Swinnerton West Village 25. Sunset Run Drive
(Scurry Bend Dr. to Lake Mead Dr.)

CITY OF LAS VEGAS INTER-OFFICE MEMORANDUM		DATE: May 4, 2020
TO: Land Development Services Department of Building & Safety		FROM: Albert Sung, P.E. Flood Control Project Engineer Department of Public Works
SUBJECT: Drainage Study for: Summerlin West Village 25 – Sunset Run Drive (Scurry Bend Dr. to Lake Mead Dr.)		COPIES TO: VTN Nevada, Inc.
Cross Streets:	Sunset Run Drive & Scurry Bend Drive	Howard Hughes Corp.
File Number:	F:\Depot\DSMemos\DS5269A.doc	Bart Anderson, P.E., DevCo
Parcel Number:	137-22-301-004	CCRFC
Zoning Action:	N/A	
FEMA Flood Zone	YES NO X	
Proposed Storm Drain	YES X NO

Addendum #1 to the Technical Drainage Study for

GRADING PLAN 1
SUMMERLIN WEST VILLAGE 25
SUNSET RUN DRIVE
SCURRY BEND DRIVE TO LAKE MEAD BOULEVARD

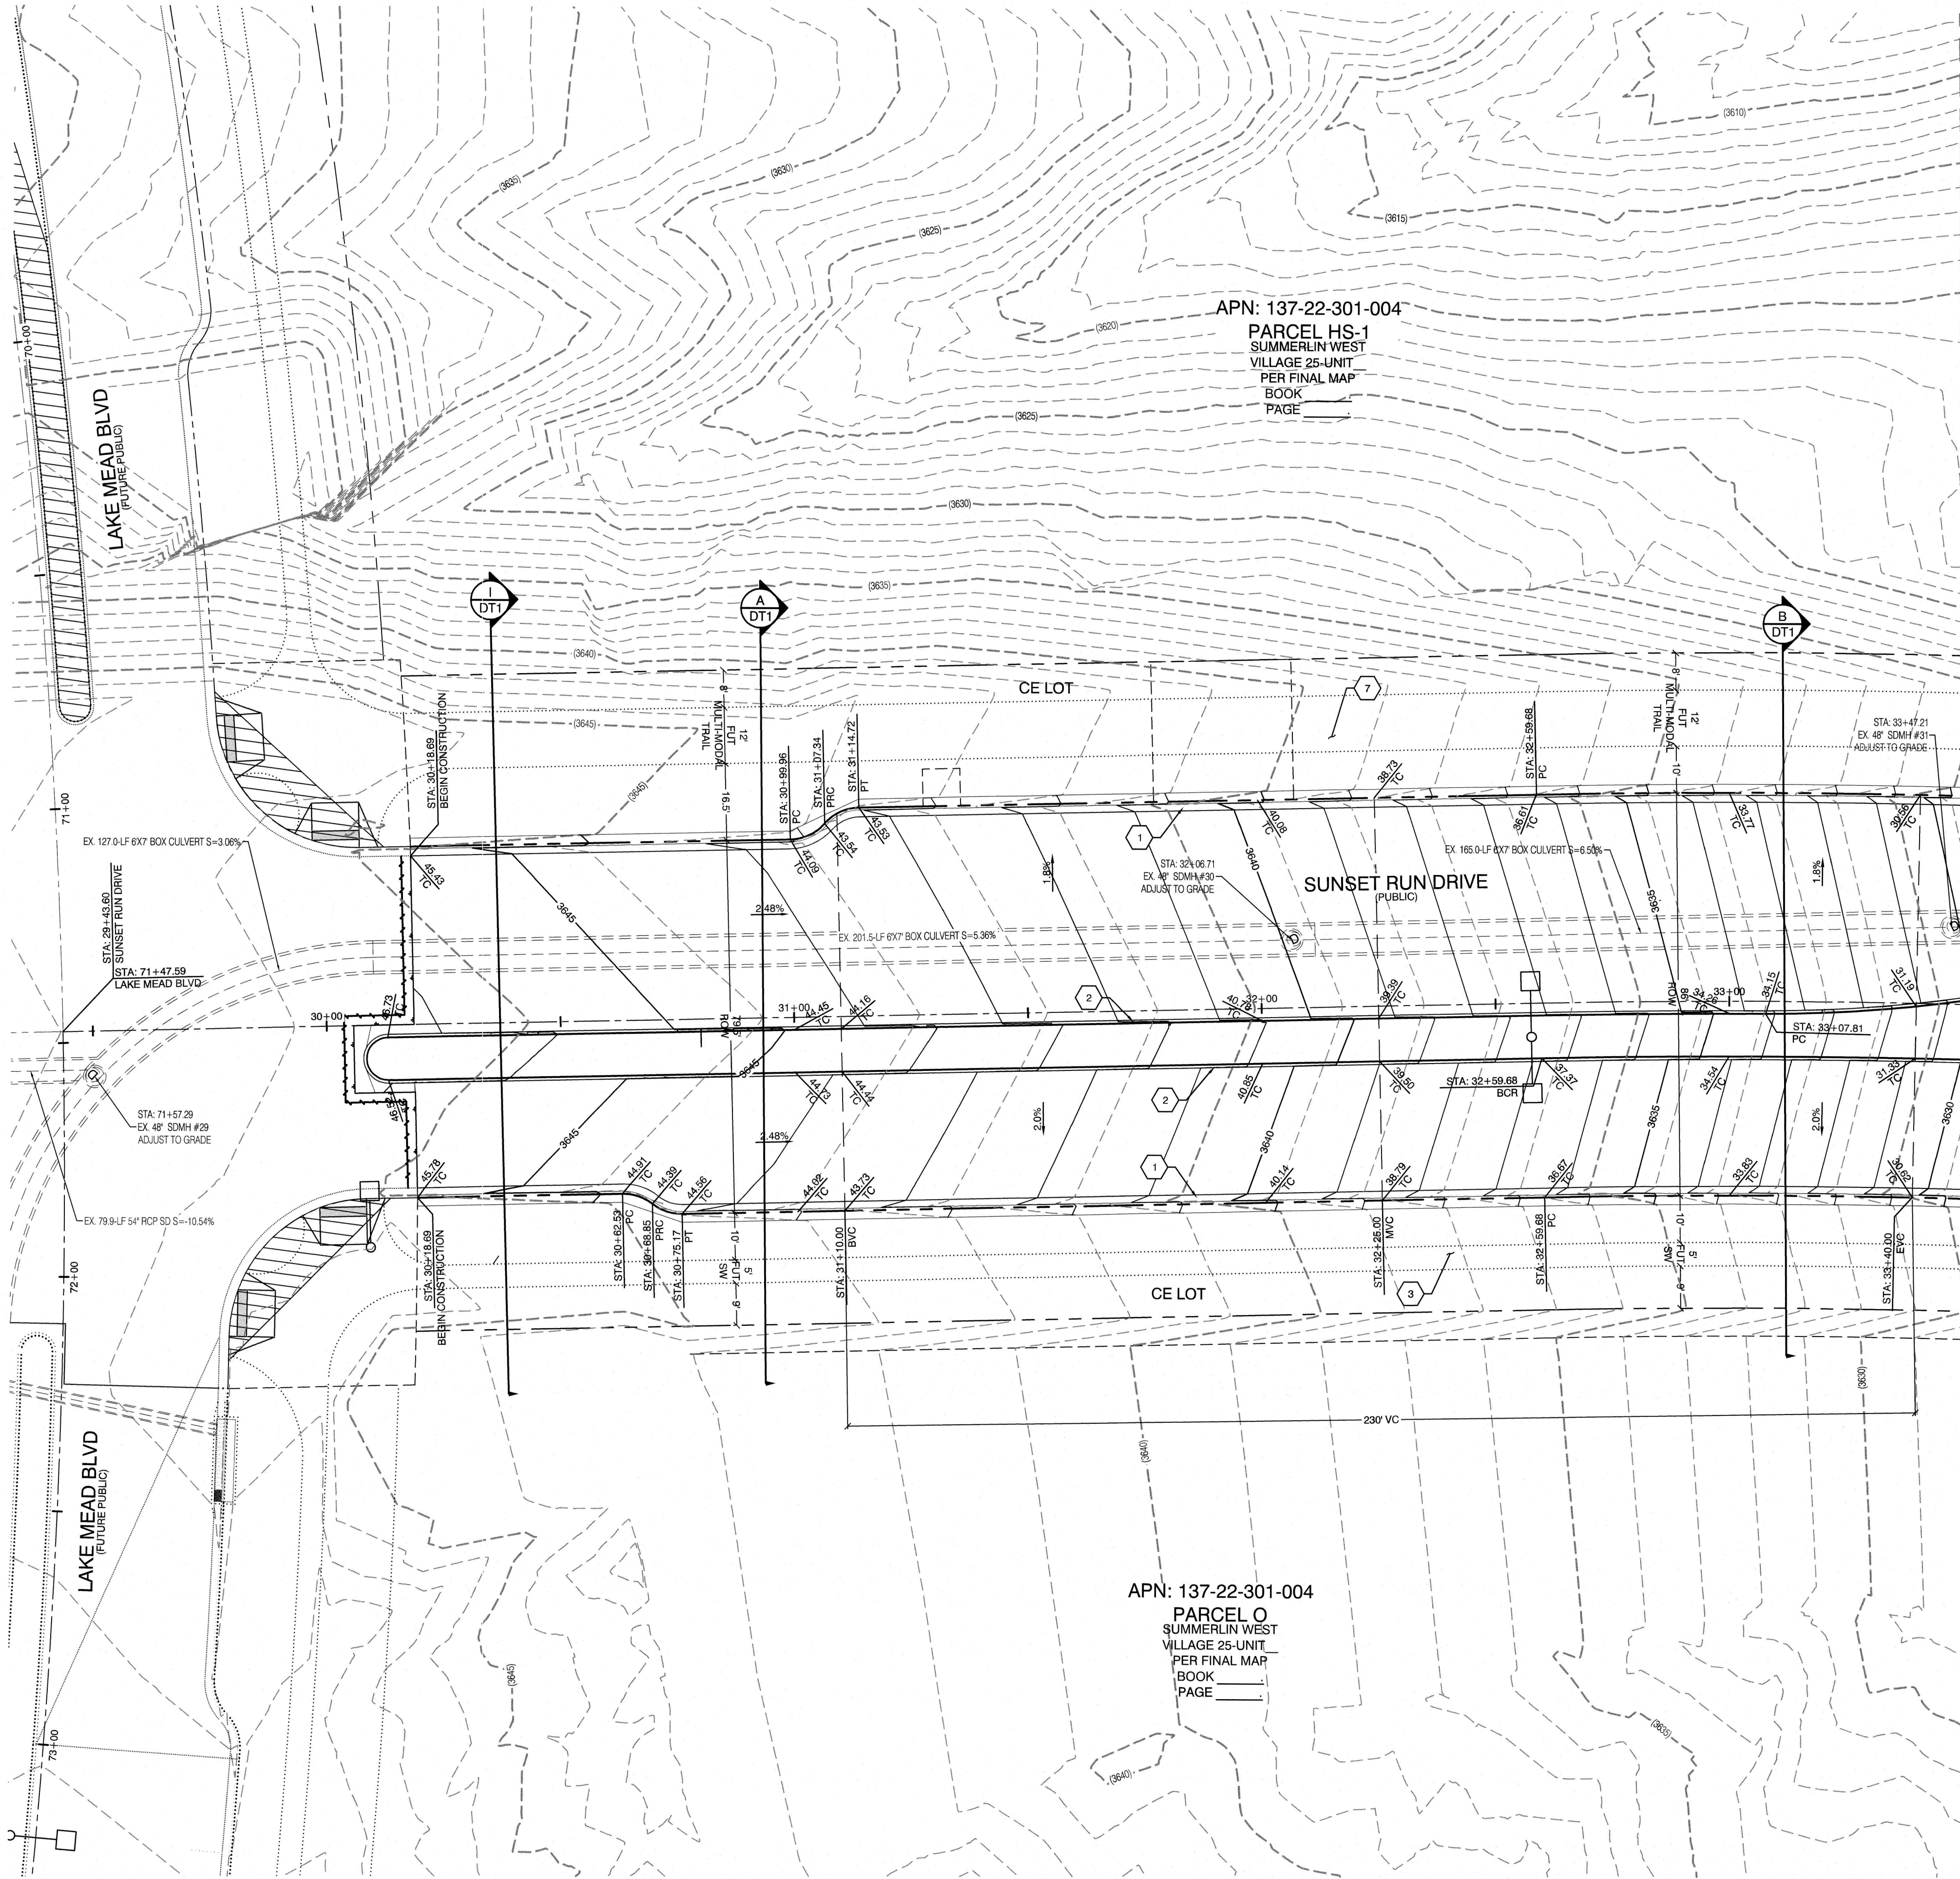
All offsite interim flood control facilities such as but not limited to berms/ditches and temporary sump are privately owned and to be privately maintained by the Howard Hughes Company. Provide a note as such on the grading plans.

RESPONSE: The requested note has been added to the grading plans.

INTERIM FLOOD CONTROL FACILITY NOTE:
ALL OFFSITE INTERIM FLOOD CONTROL FACILITIES SUCH AS BUT NOT LIMITED TO BERMS/DITCHES AND TEMPORARY SUMPS ARE PRIVATELY OWNED AND TO BE PRIVATELY MAINTAINED BY THE HOWARD HUGHES COMPANY

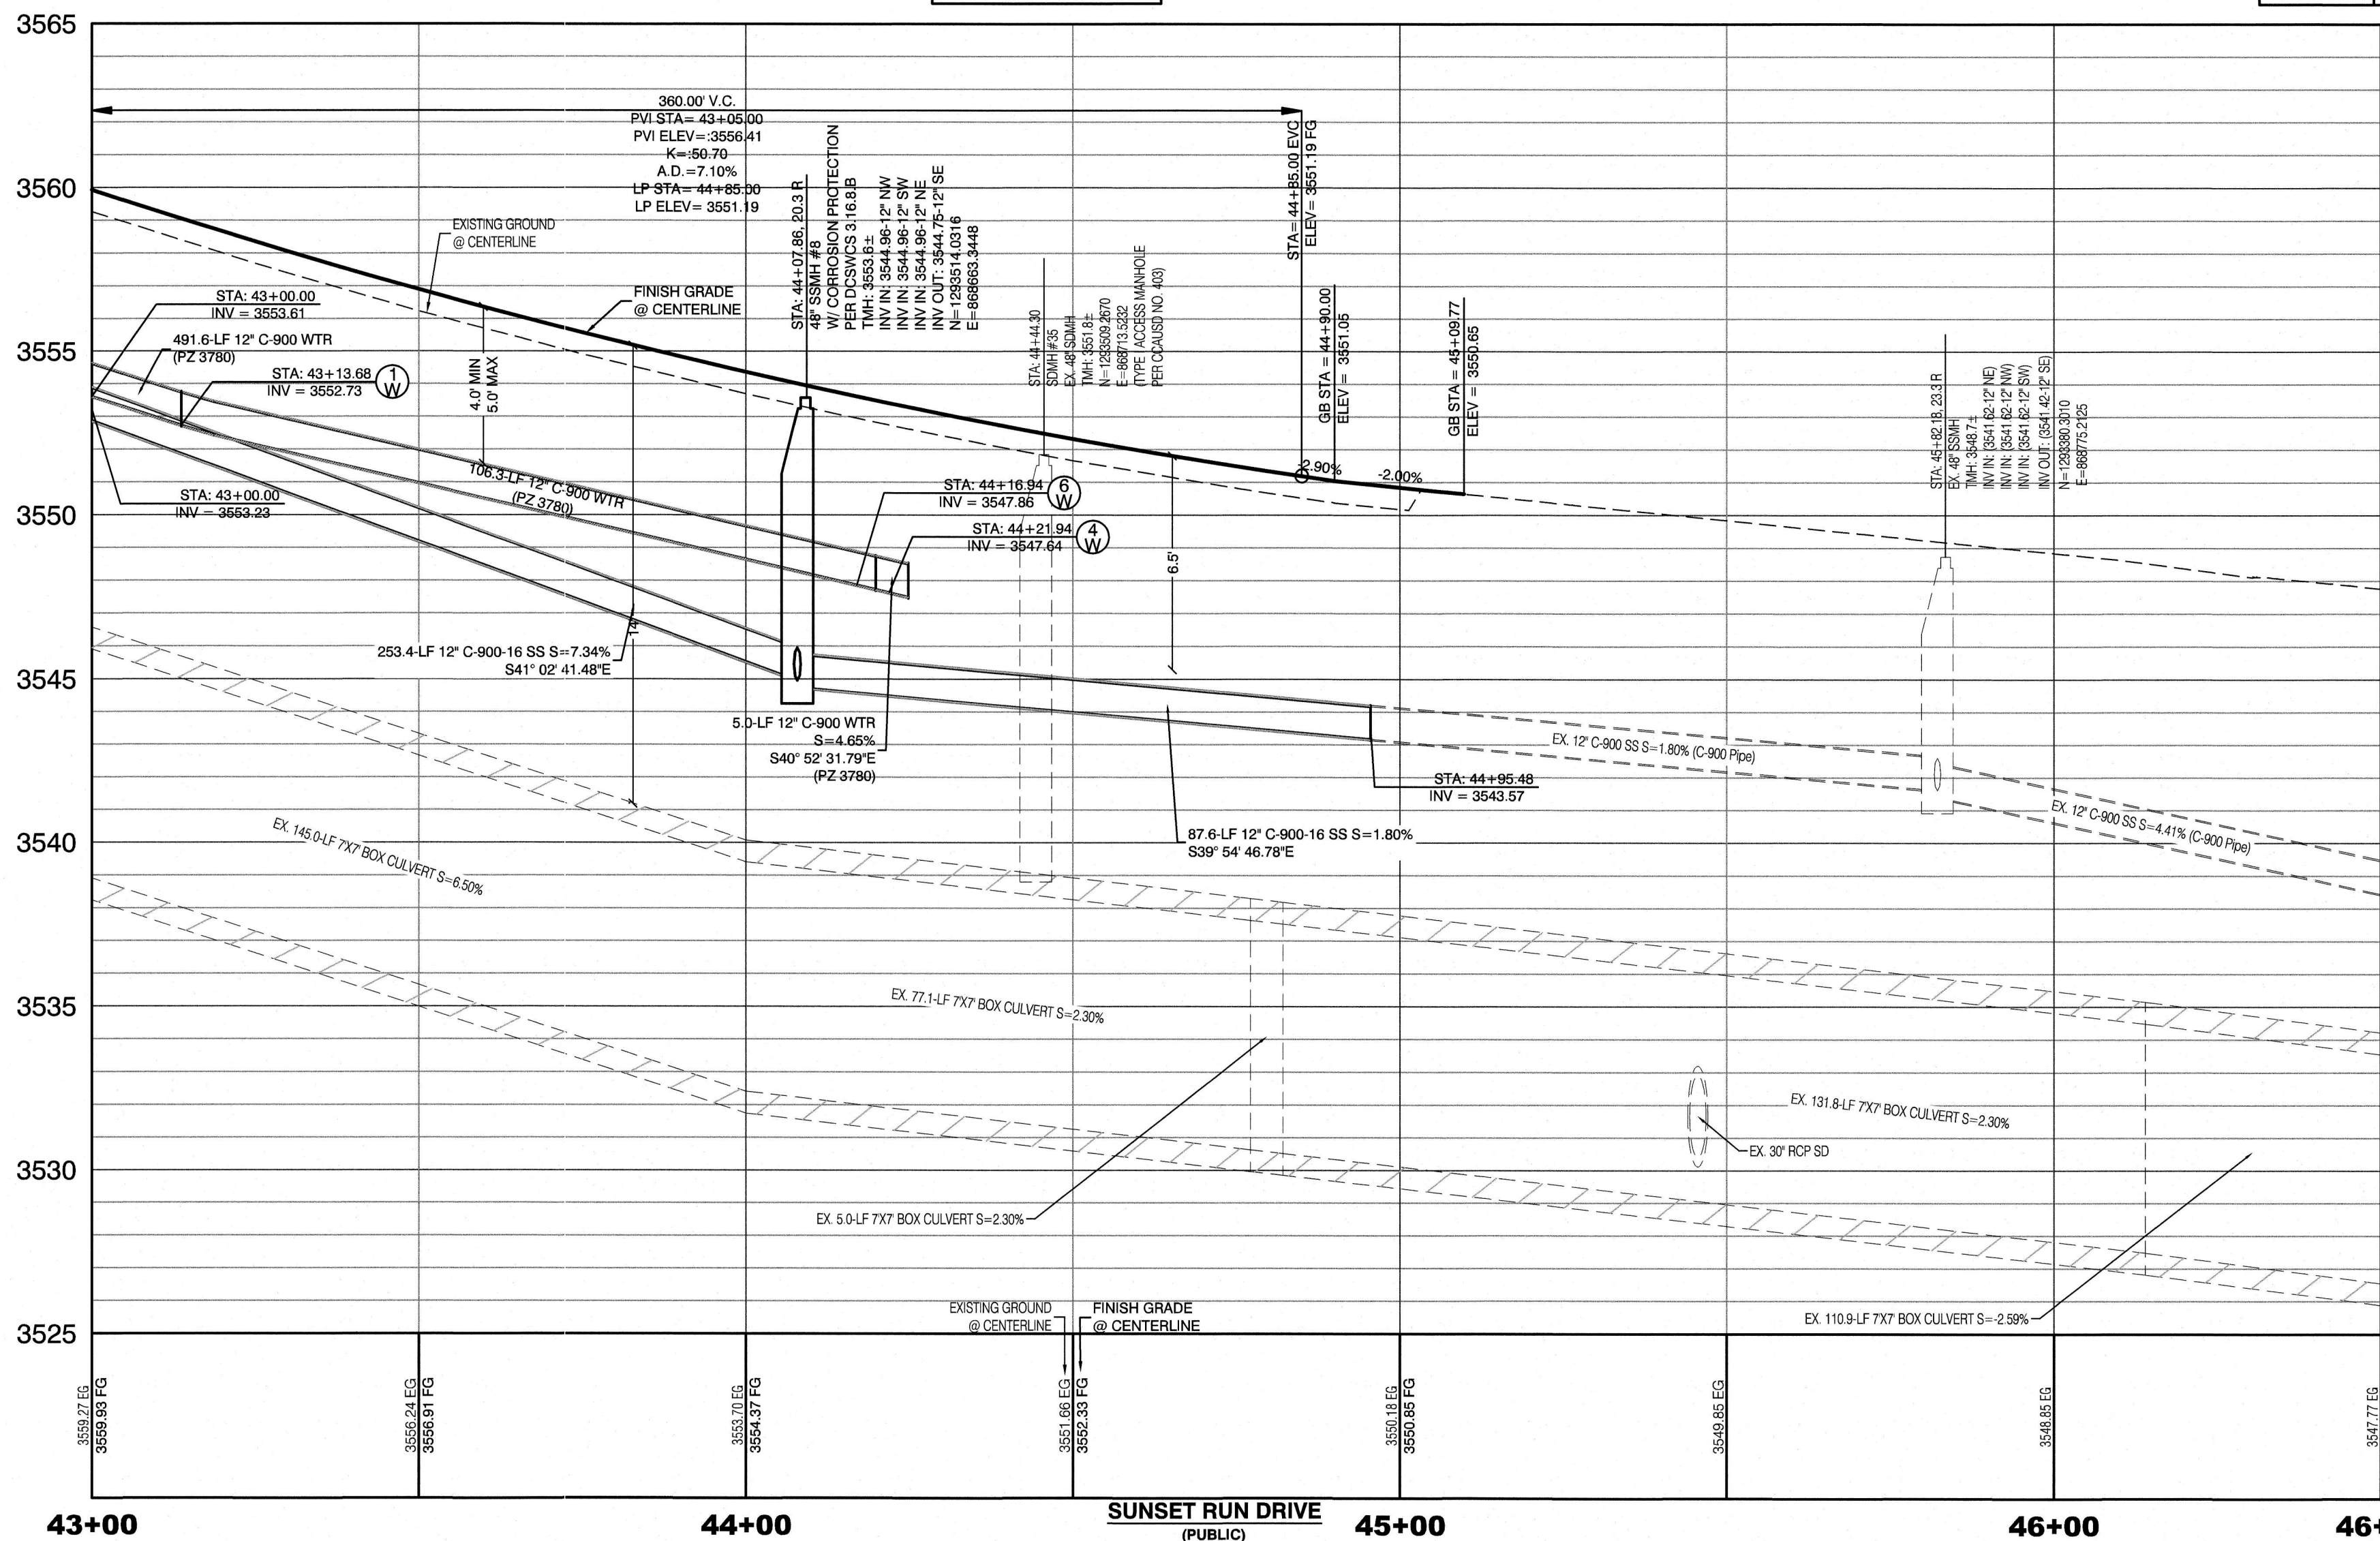
Label the depth of proposed drop inlets in all pertinent plans.

RESPONSE: The depth of the proposed drop inlets can be calculated from the drop inlet invert and top of curb elevation labeled on the plans. The following table summarizes the depth of each drop inlet. A table summarizing the drop inlet depths has also been added to the plans.

SDDI #	STATION	RIGHT/LEFT	TC ELEVATION	INV OUT ELEVATION	DEPTH
SDDI #1	37+36.23	LEFT	3599.69	3598.17	13.52
SDDI #2	37+49.80	RIGHT	3598.88	3590.63	8.25
SDDI #3	44+73.14	LEFT	3551.16	3542.17	8.99
SDDI #4	44+82.24	RIGHT	3550.81	3541.88	8.93
